Quazi Abedin Tex Ltd

Shovapur, Rajfulbaria, Savar, Dhaka
(23.807356N, 90.258660E)
8th February 2017

Observations

Poor Connection Details-Wastage storage

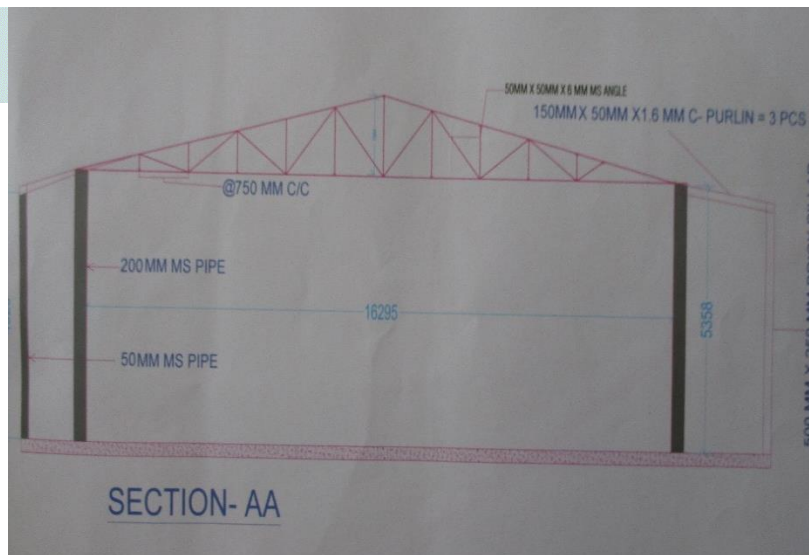
Steel sheds were seemed to be non engineered. Poor connection in joints, some defecate members were observed. Building engineer is required to check the connections and defected structural member of sheds .

Roof supported by slender pipe post.

Drawings shows dining sheds roof truss is Pratt truss on site Howe truss system was observed. Building Engineer is required to check the stability against lateral loading and produce an as built drawings for dining shed.
